**Addendum Number 03  
(June 19, 2024)**

**EDINBURG CTE CENTER**

PBK Project No.: 20217

**ECISD Barrientes – Edinburg CTE Center  
Addendum #3**

S-402  
 PARTIAL ROOF FRAMING PLAN - AREA B  
 FOR BLUEBEAM LABELING:OOR  
 File Path: Autocad Docs/Edinburg CSD\_20215 ECISD Barrientes MS - CTE Renovations - R2 - Central\_vacillio.rvt  
 CHECKED BY: CC  
 DRAWN BY: VDV  
 Plot Stamp: 6/19/2024 4:23:59 PM

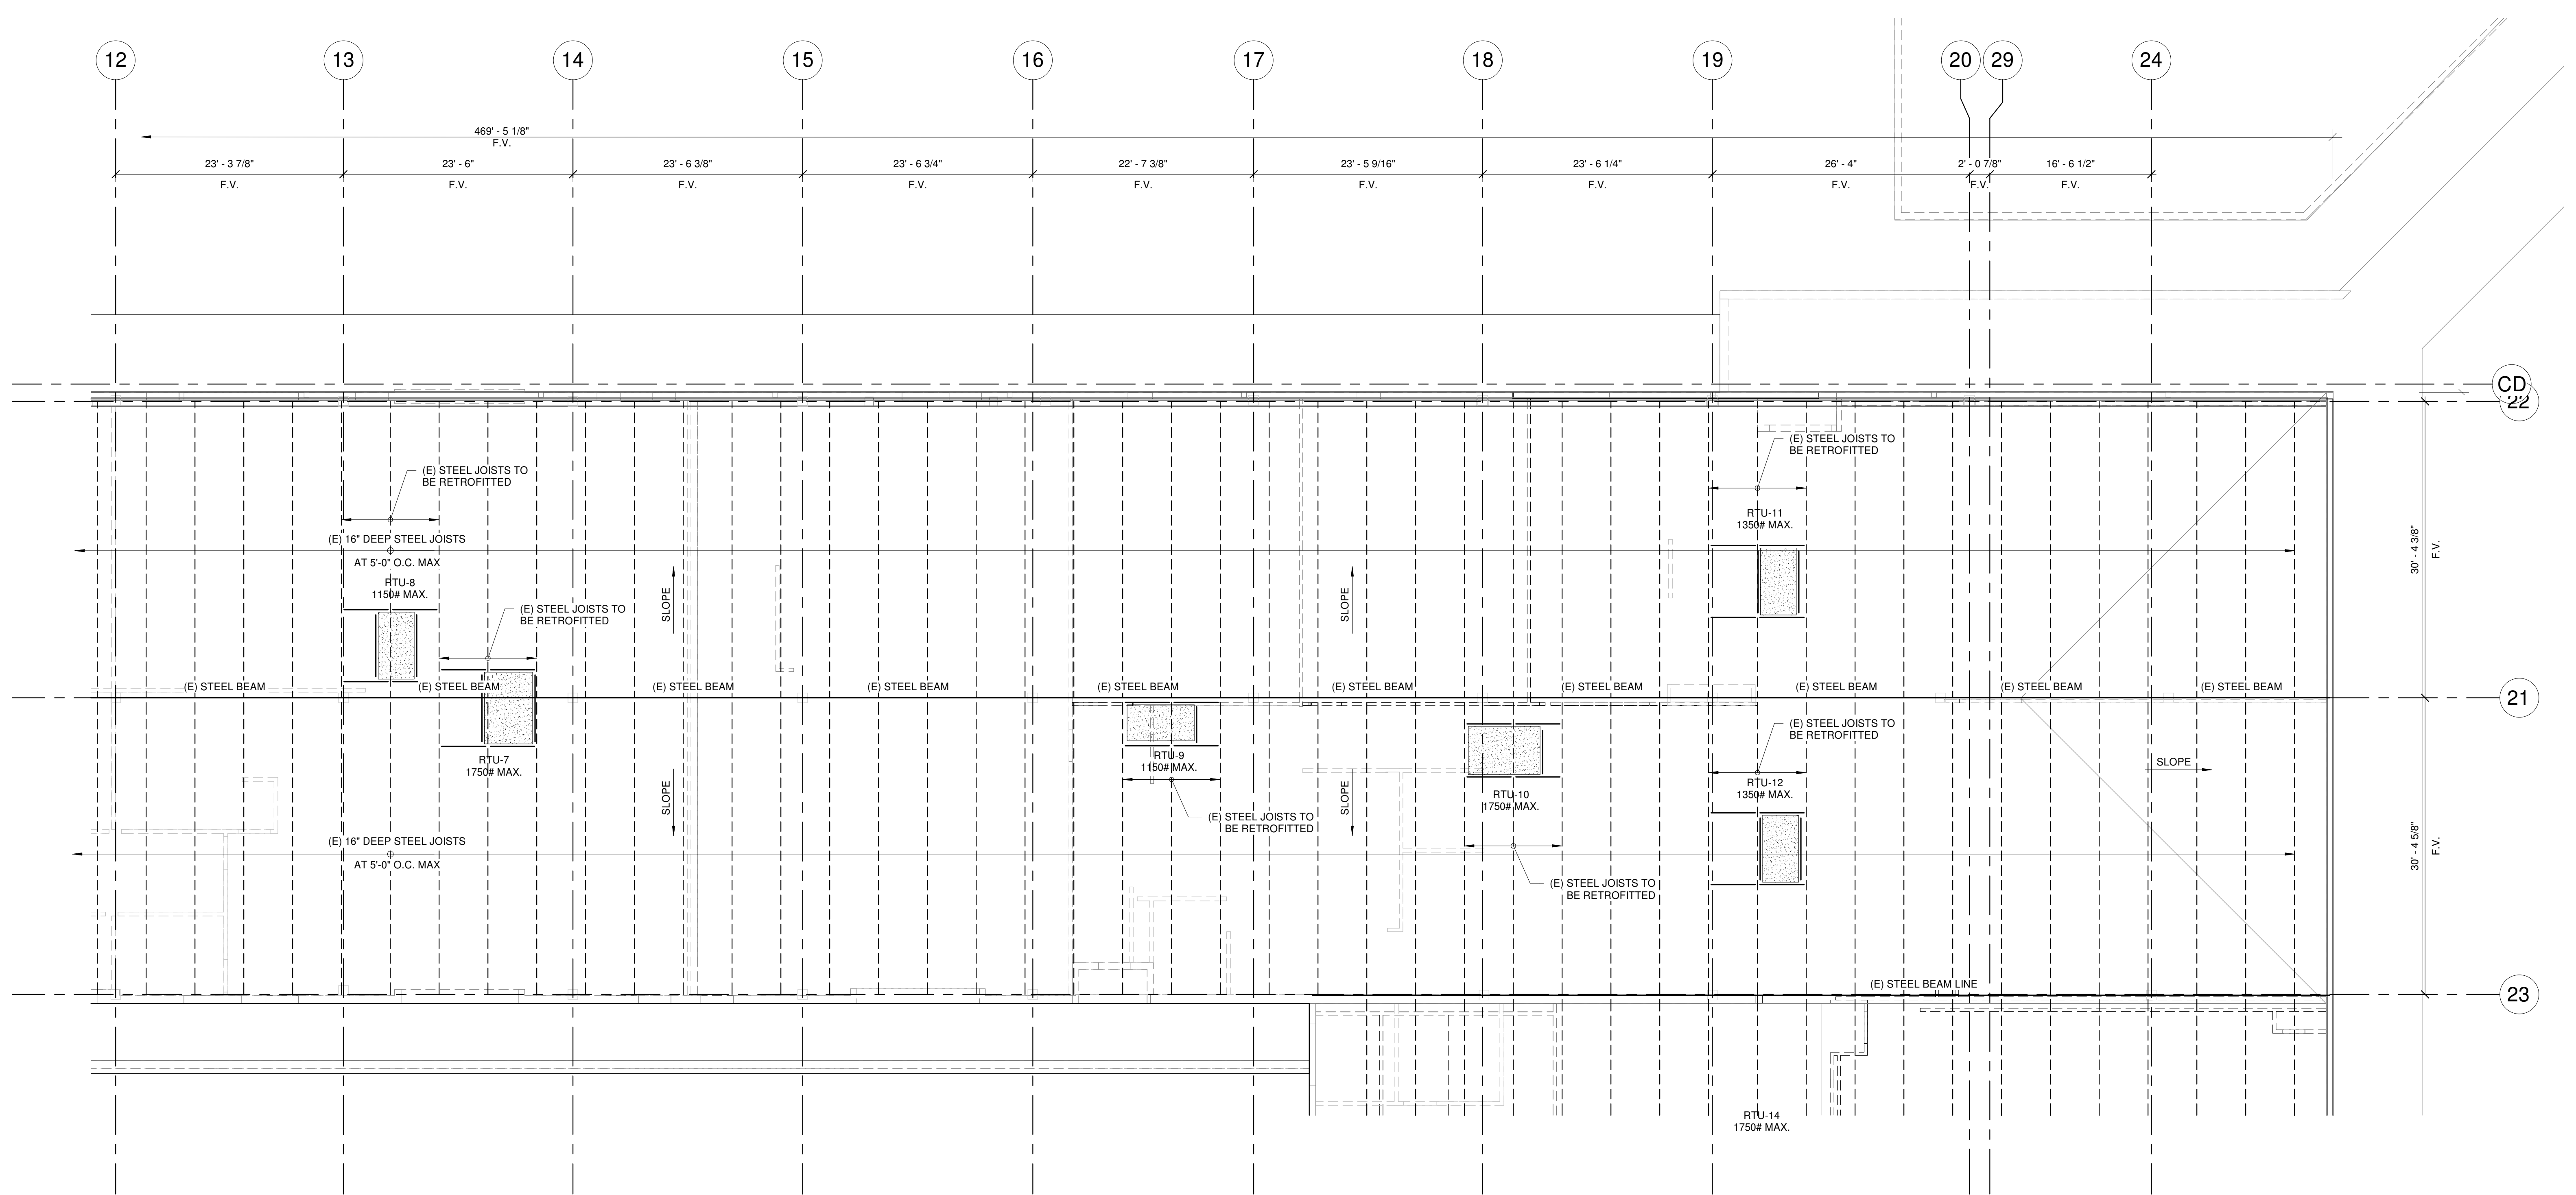
| 016 | S-402 – Partial New Foundation Plan – Area B   | Updated locations of mechanical roof top units. Delete in its entirety. Replace with revised Sheet S-402. Refer to attached.   |             |

- Updated locations of mechanical roof top units. Delete in its entirety. Replace with revised Sheet S-402. Refer to attached.

S-200

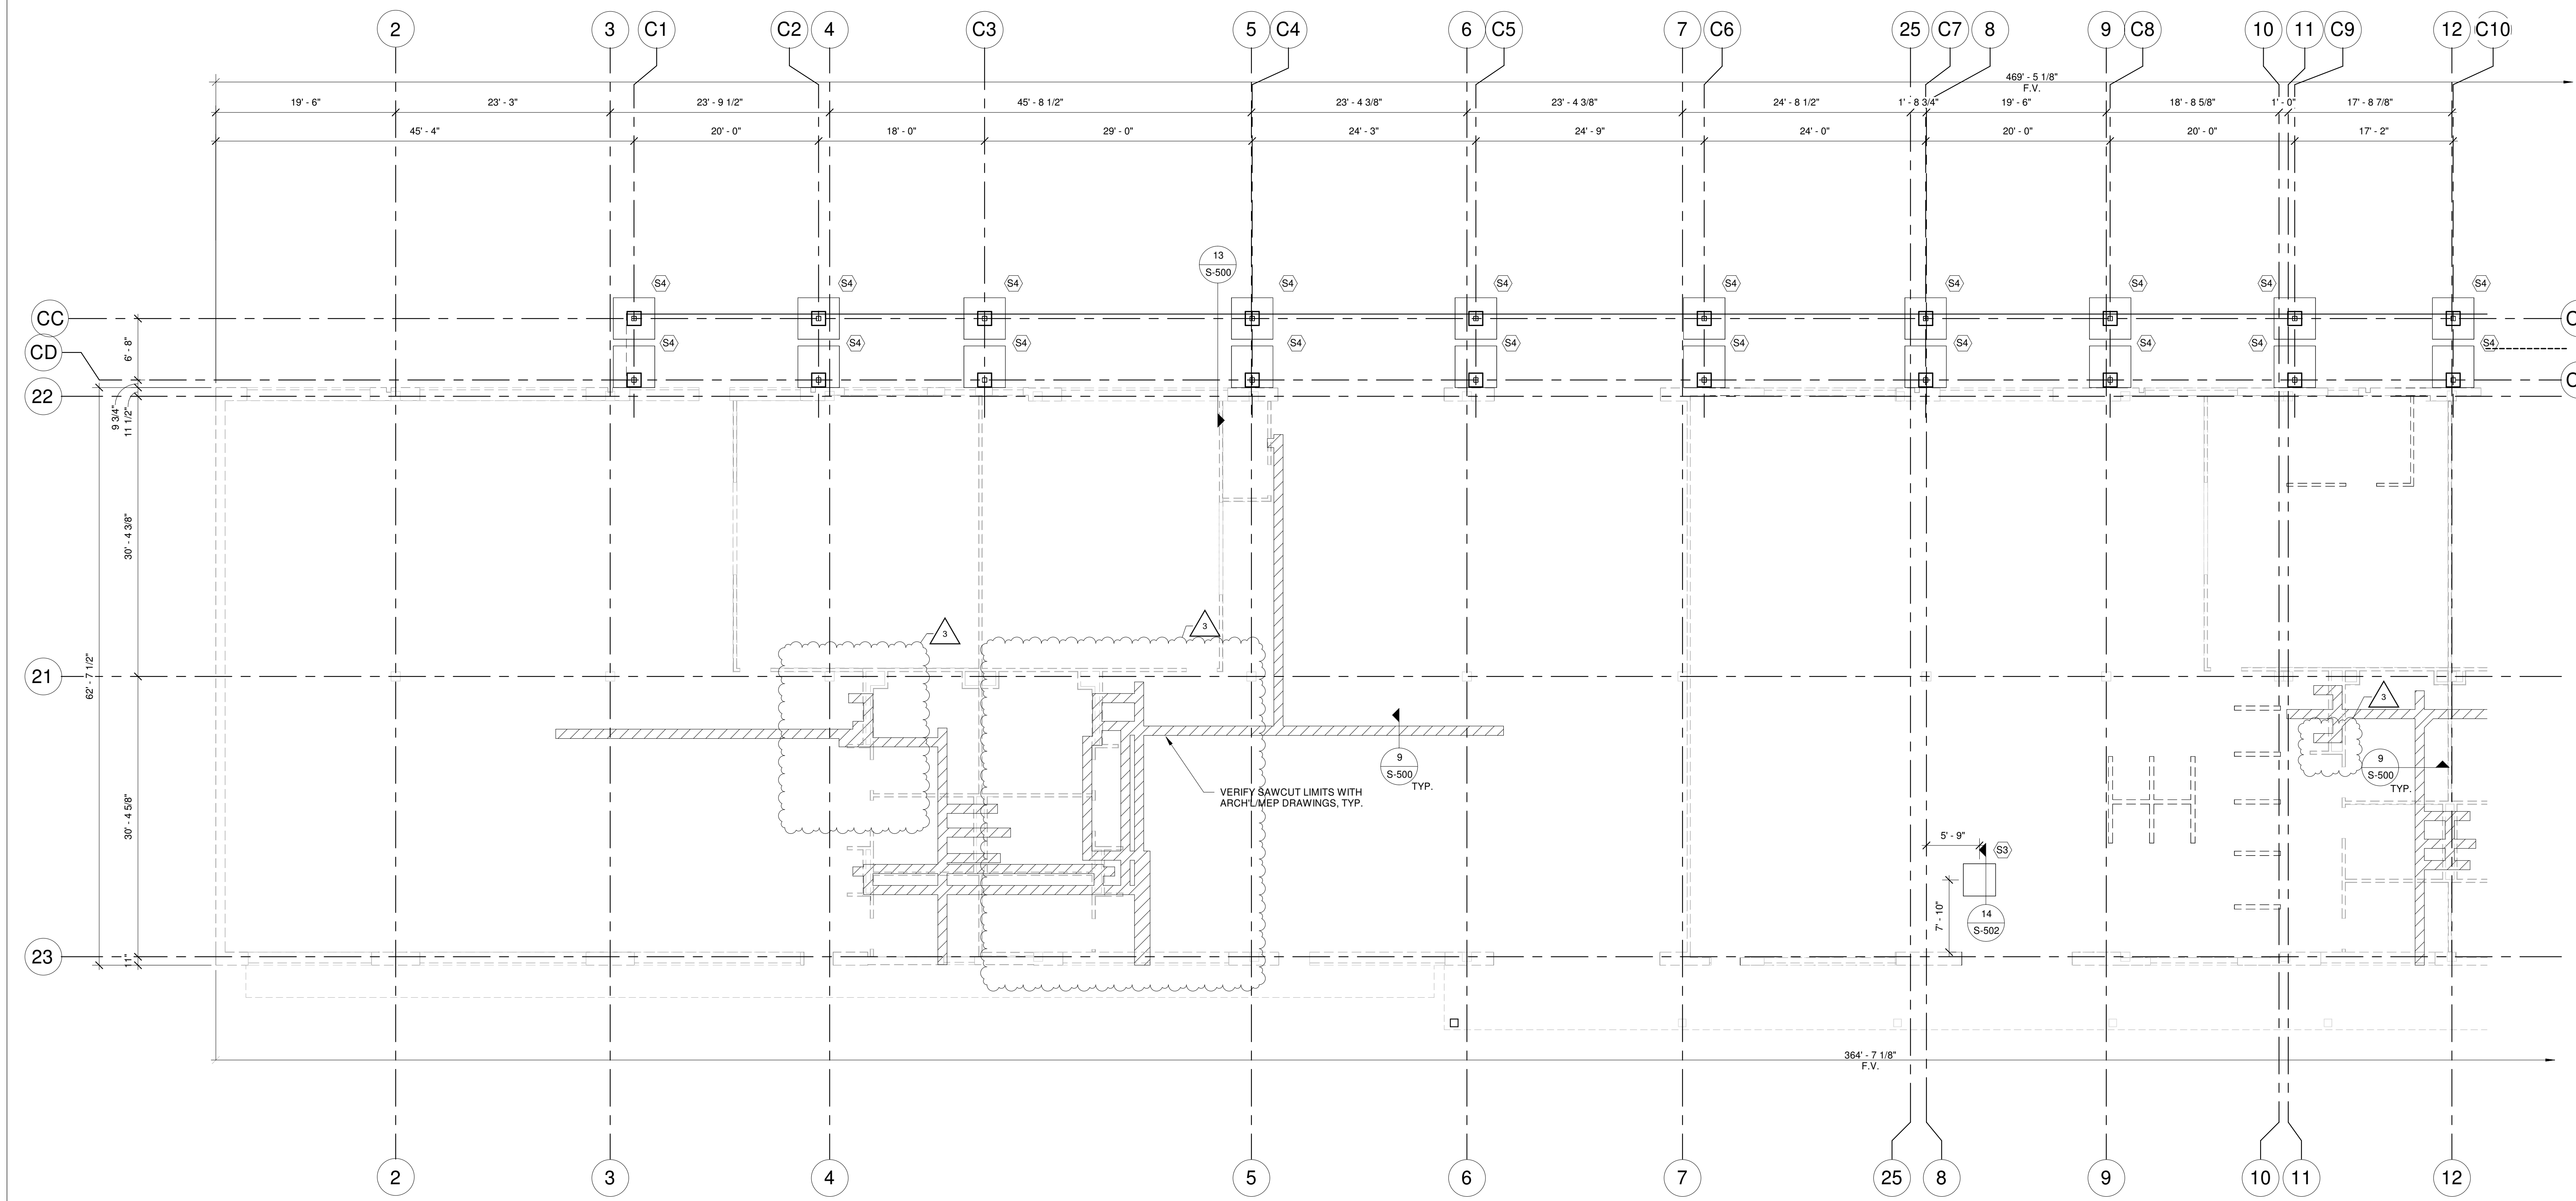
| 010 | Revised structural sheets:<br>S-200 – Overall New Foundation Plan  | Updated limit of sawcut trenches based on updated plumbing modifications. Delete in its entirety. Replace with revised Sheet S-200. Refer to attached.   |             |

- Updated limit of sawcut trenches based on updated plumbing modifications. Delete in its entirety. Replace with revised Sheet S-200. Refer to attached.

PARTIAL NEW  
 FOUNDATION PLAN -  
 AREA A

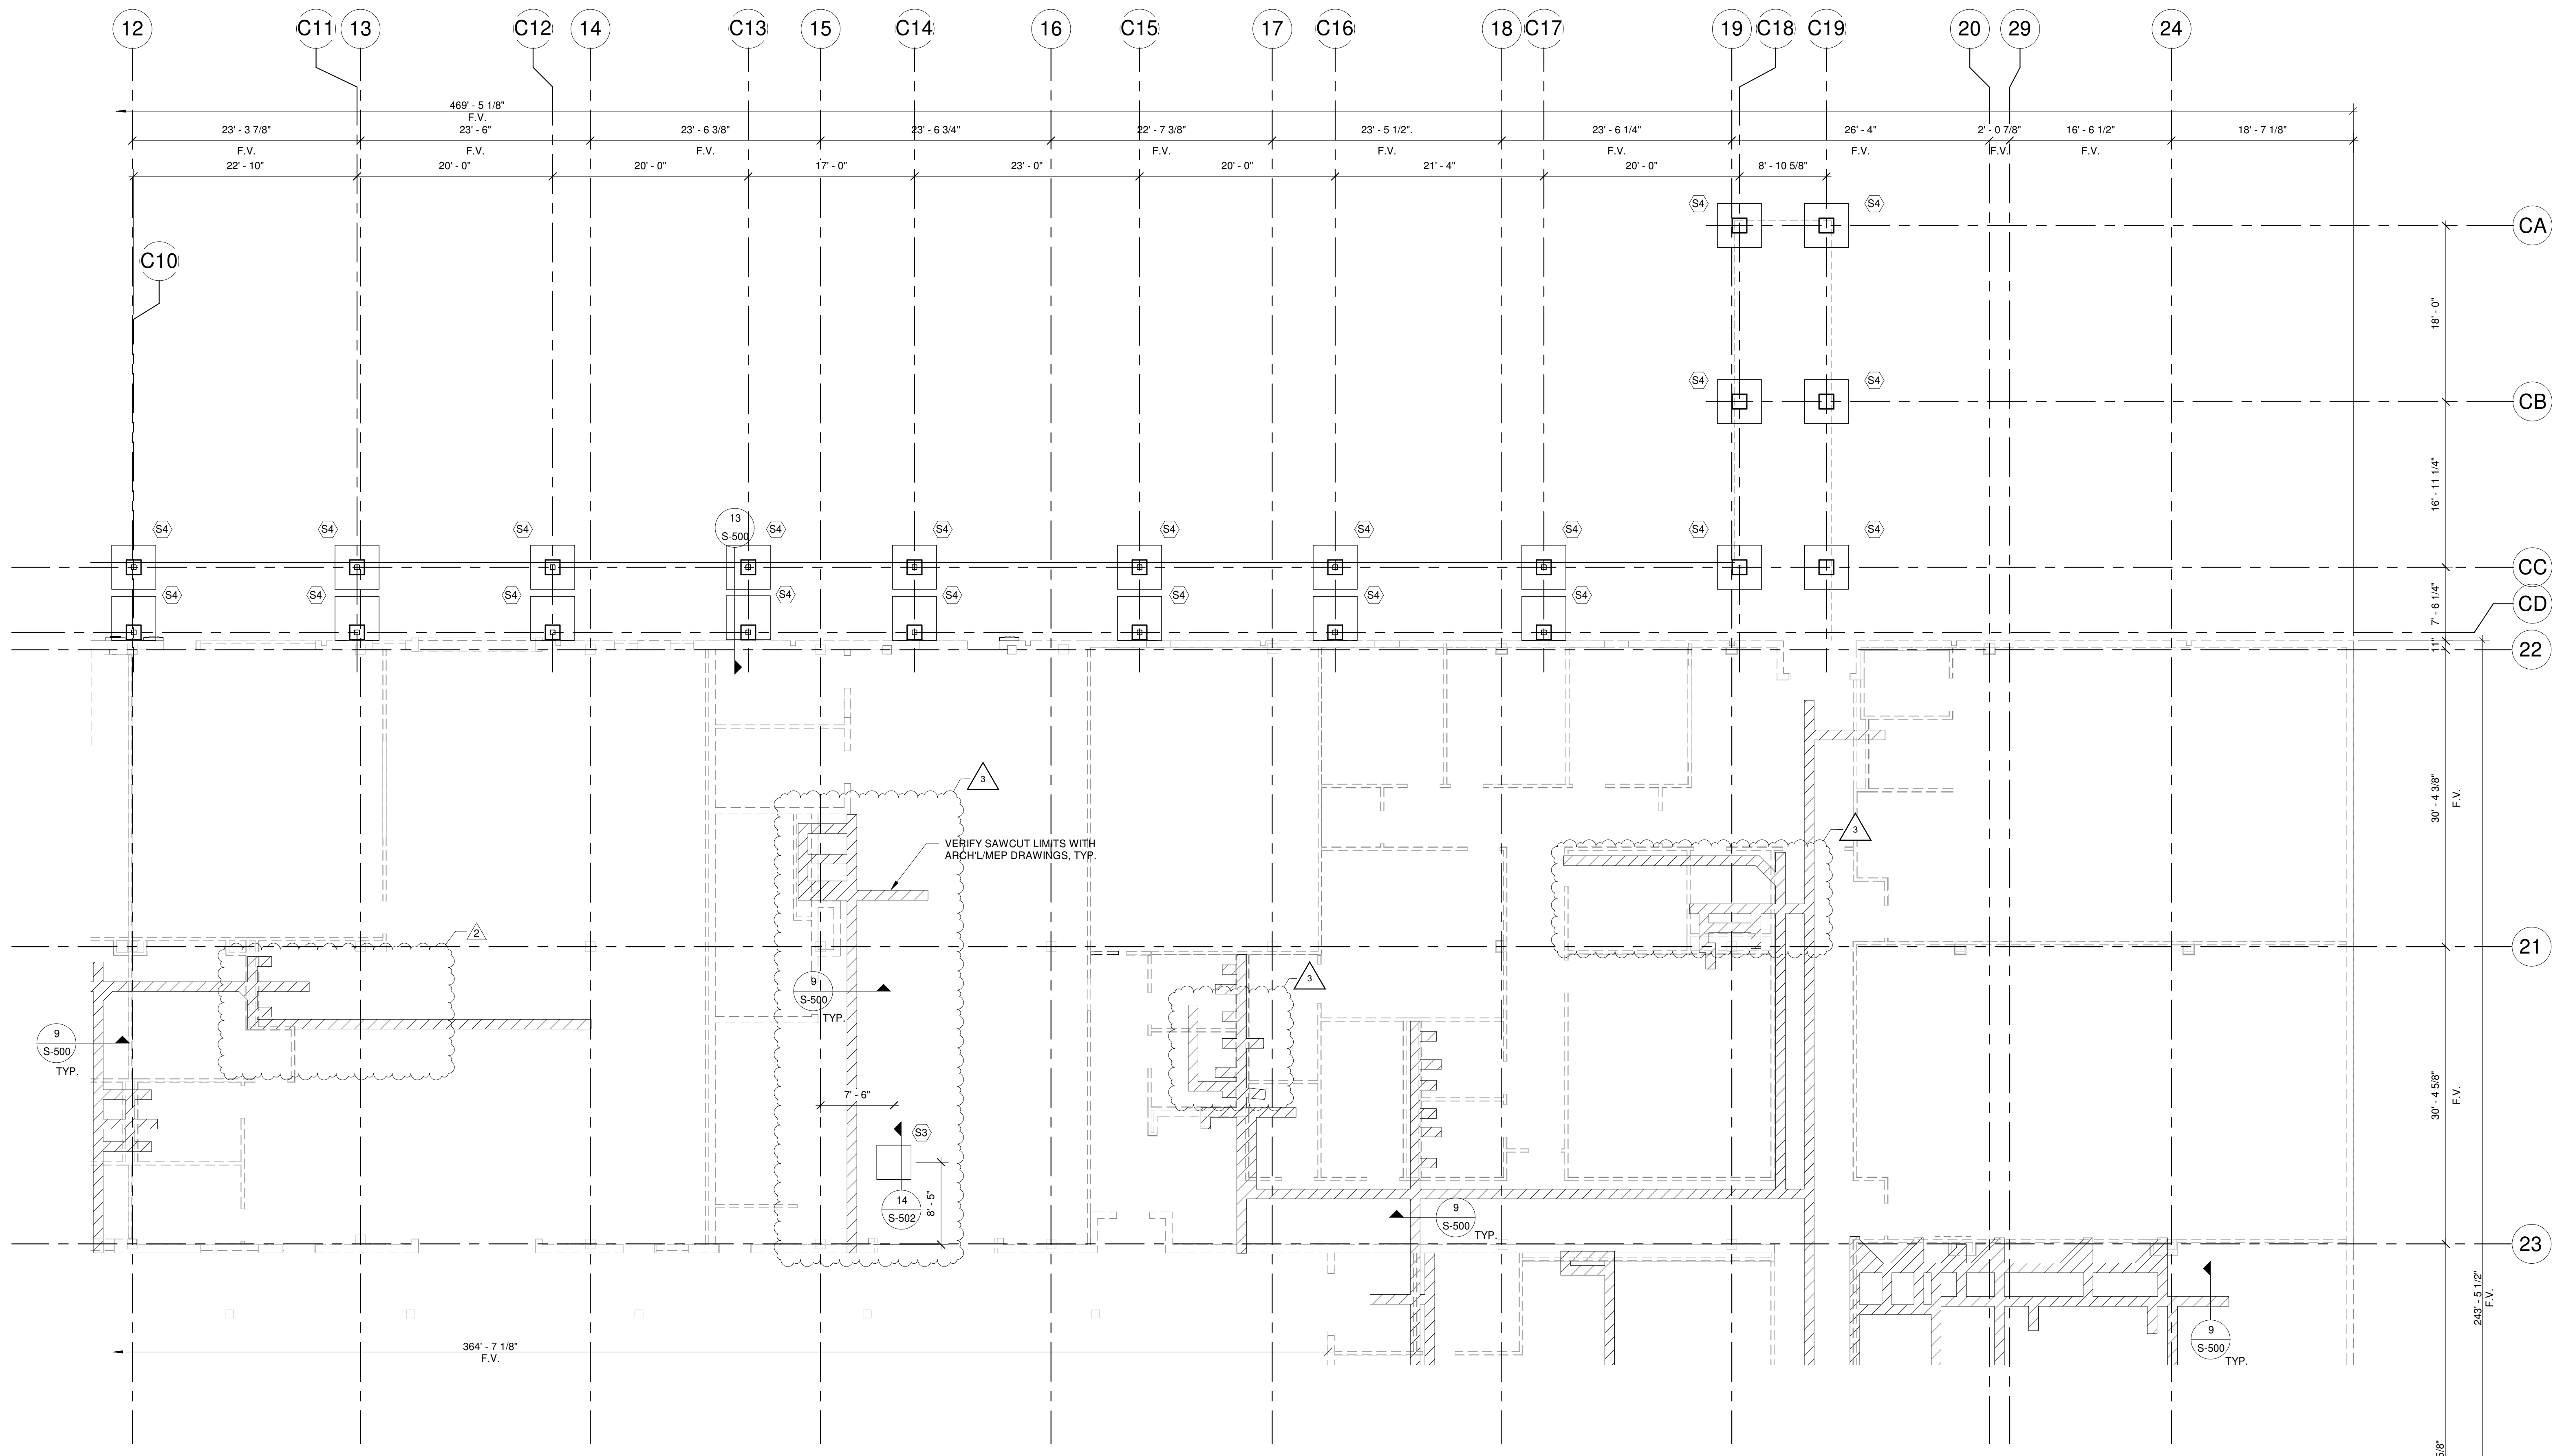
| 011 | S-201 – Partial New Foundation Plan – Area A   | Updated limit of sawcut trenches based on updated plumbing modifications. Delete in its entirety. Replace with revised Sheet S-201. Refer to attached.   |             |

- Updated limit of sawcut trenches based on updated plumbing modifications. Delete in its entirety. Replace with revised Sheet S-201. Refer to attached.
